SUBJECT: Chicago Executive Airport
Wheeling/Prospect Heights, Illinois
Cook County
Illinois Project Number: PWK-4407
SBG Project Number: 3-17-SBGP-XX
Contract No. PA057
Item No. 7A, August 1, 2014 Letting
Addendum A

NOTICE TO PROSPECTIVE BIDDERS

Revisions based on utility information and reviews for watermain and telecommunications.

CONSTRUCT ENGINEERED MATERIALS ARRESTING SYSTEM (EMAS) PHASE 3A - RUNWAY 16 END (34 DEPARTURE END) INCLUDING RUNWAY 16/34 OFA/RSA IMPROVEMENTS AND SITEWORK

Plan Sheet 18 of 31, **Drainage and Utility Details – Sheet 3:**

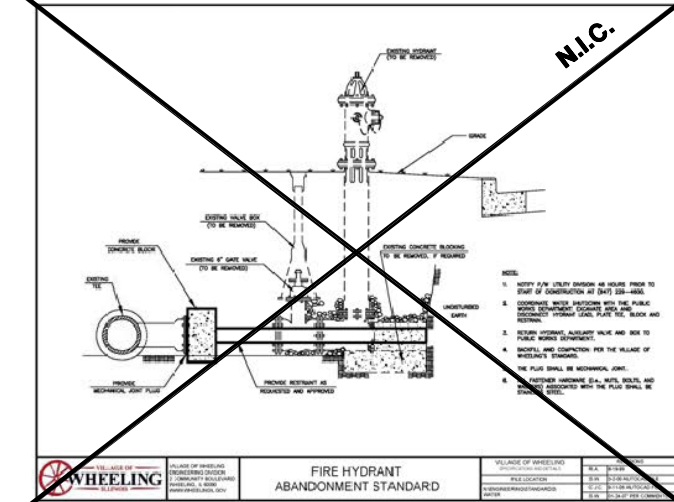
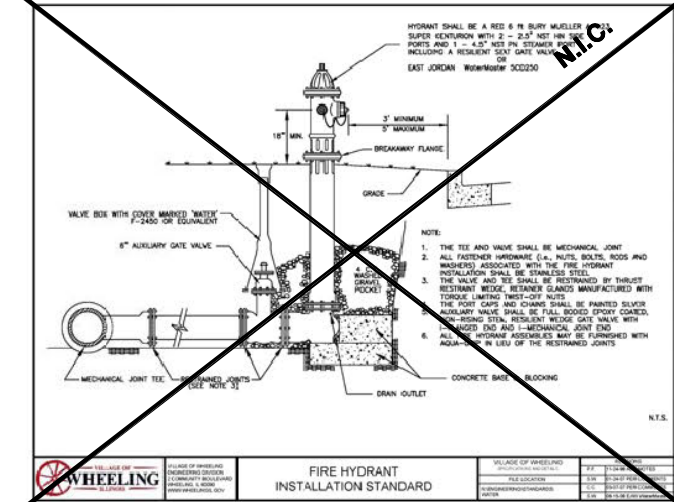
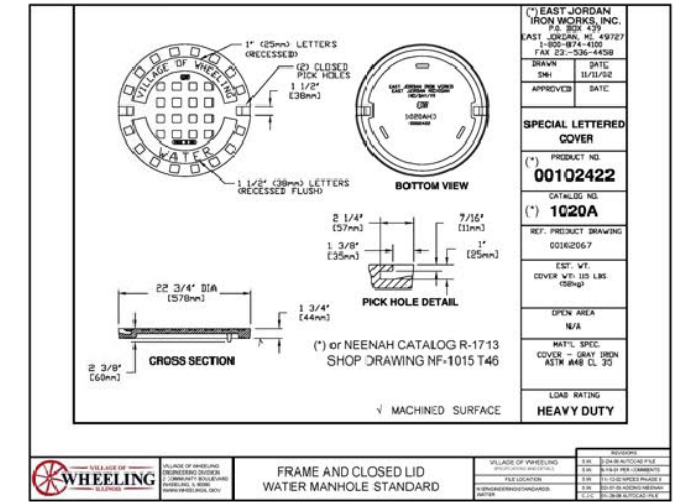
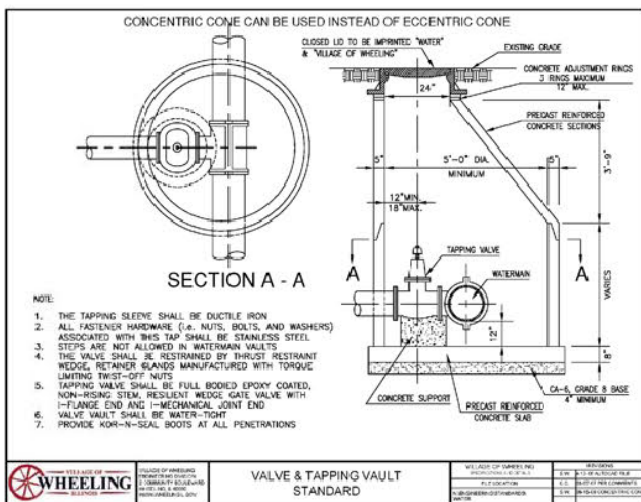
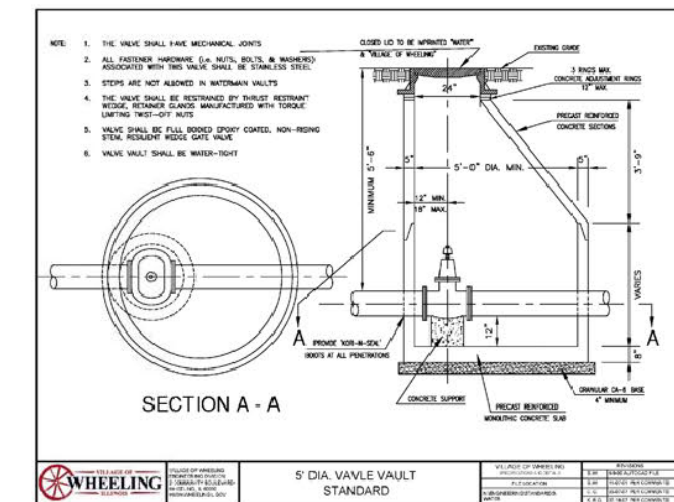
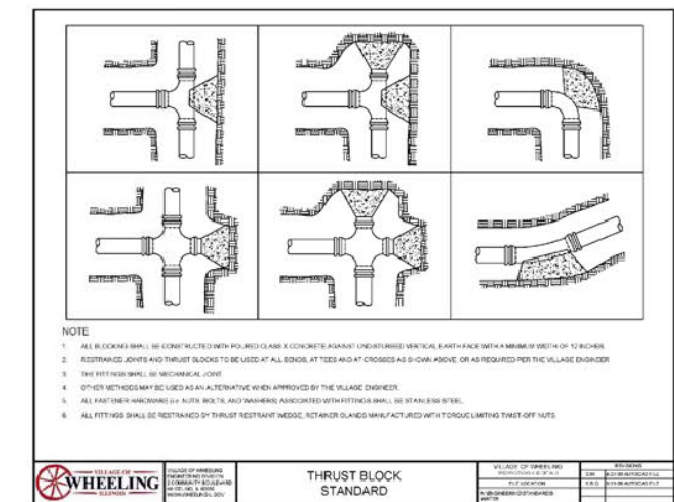
Revised and added details.

Plan Sheet 27 to 30, **Cross Sections:**

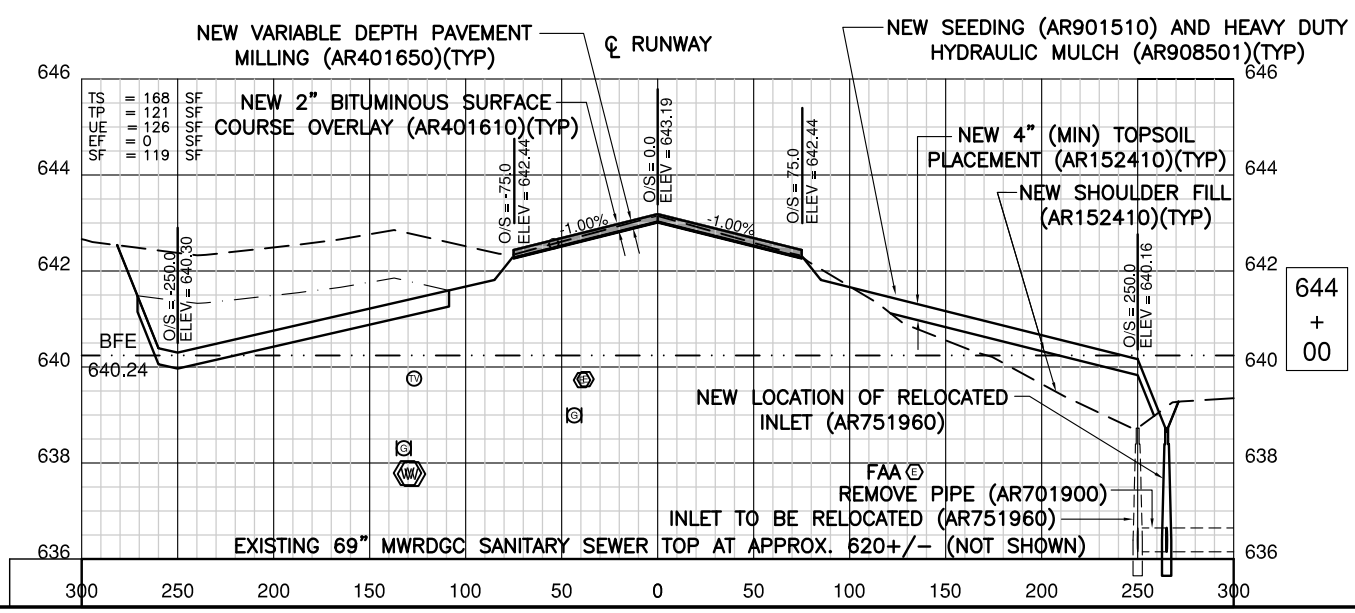
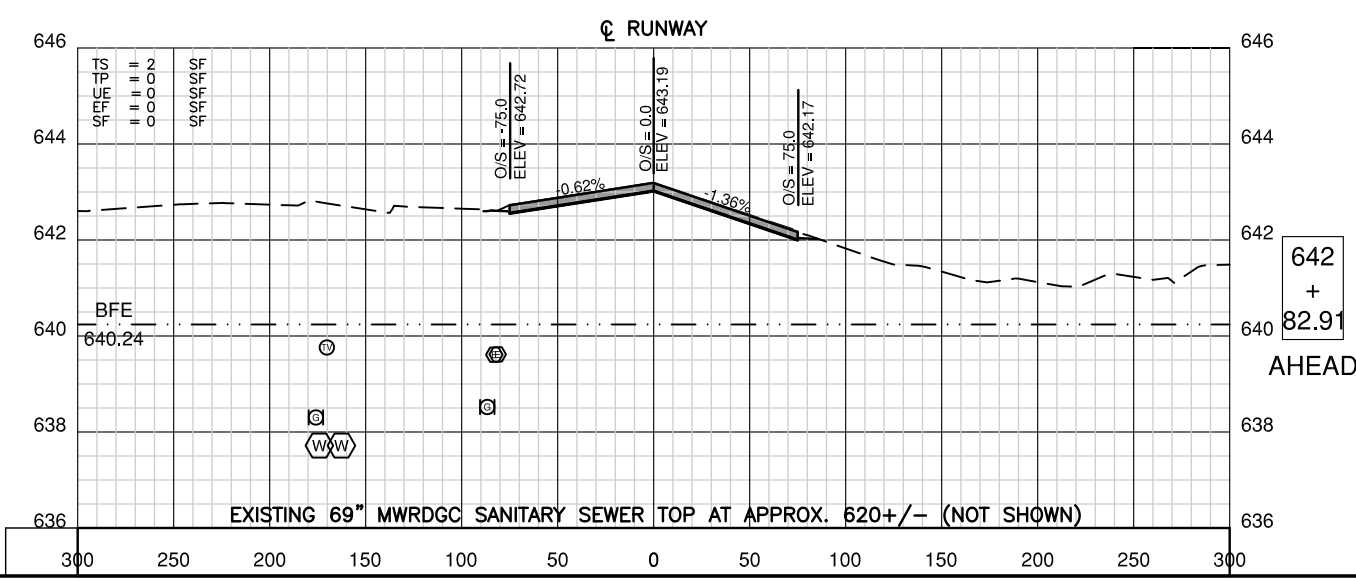
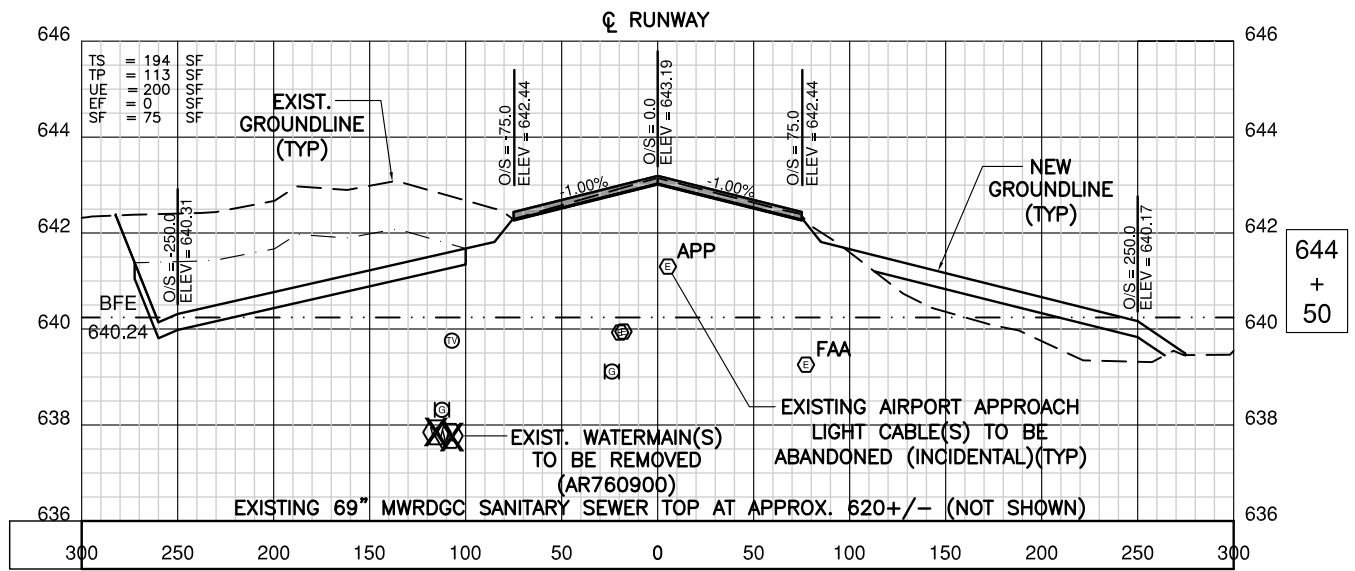
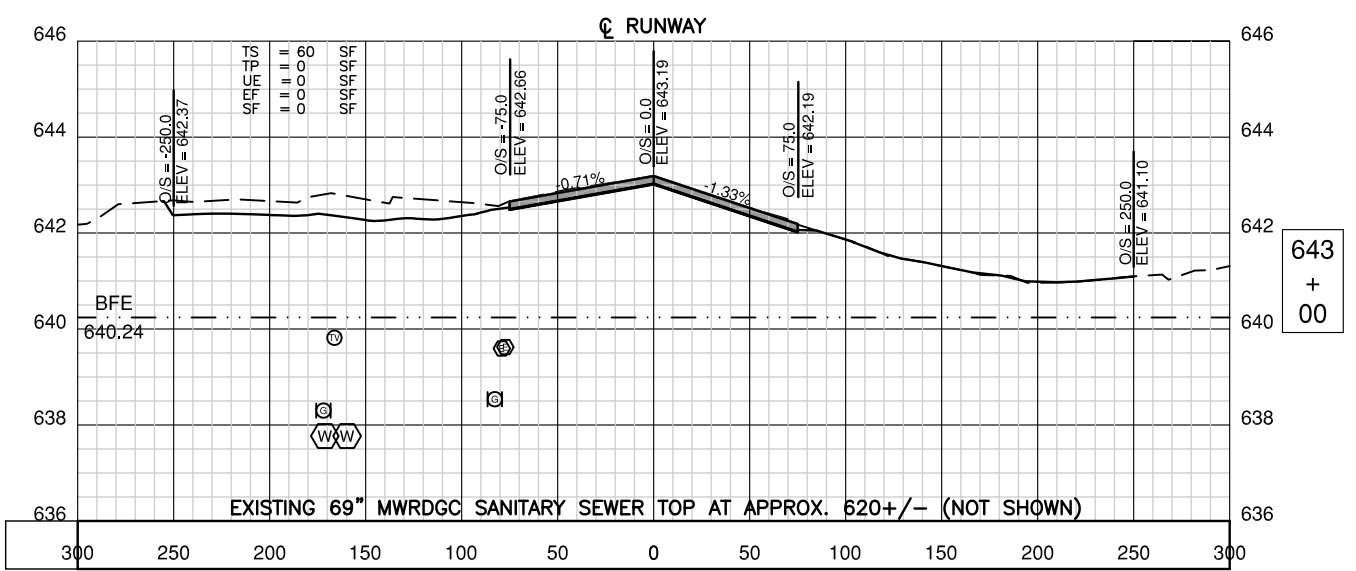
Revised information for utilities in sections.
